**Economic Commission for Europe****Inland Transport Committee****Working Party on the Transport of Dangerous Goods****Joint Meeting of the RID Committee of Experts and the
Working Party on the Transport of Dangerous Goods**

**Proposals for amendments to RID/ADR/ADN:
new proposals****Exemption under 1.1.3.3****Transmitted by the Government of Switzerland^{1,2}***Summary*

Example of a heating system for the vehicle sheets

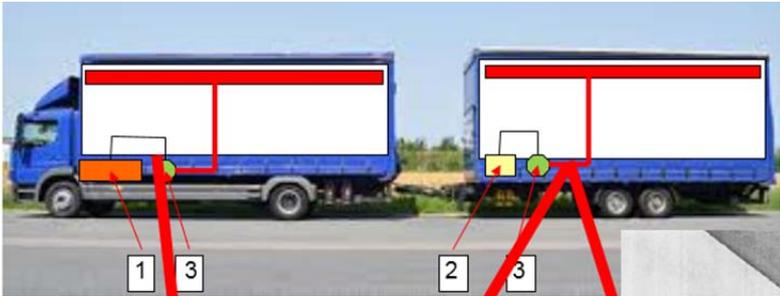
5. To illustrate this issue, we present in the annex an example of a heating system intended to prevent snow and ice from accumulating on the roof of a vehicle.

- 1. Fuel for towing vehicle
 - No external use, use only during carriage
 - Vehicle tank for propulsion and use of resultant heat for heating
 - ADR does not provide for this combination of uses
- 2. Trailer heating tank
 - No external use, use only during carriage
 - Diesel, but used only as heating fuel, not as motor fuel
 - 25-litre tank
- 3. Heater

6. (This proposal does not apply to the English version.) In the French version of 1.1.3.3, replace “*carburants*” with “*combustibles*” in the title and “*carburant*” with “*combustible*” each time it appears in the text (five times in RID, nine times in ADR).
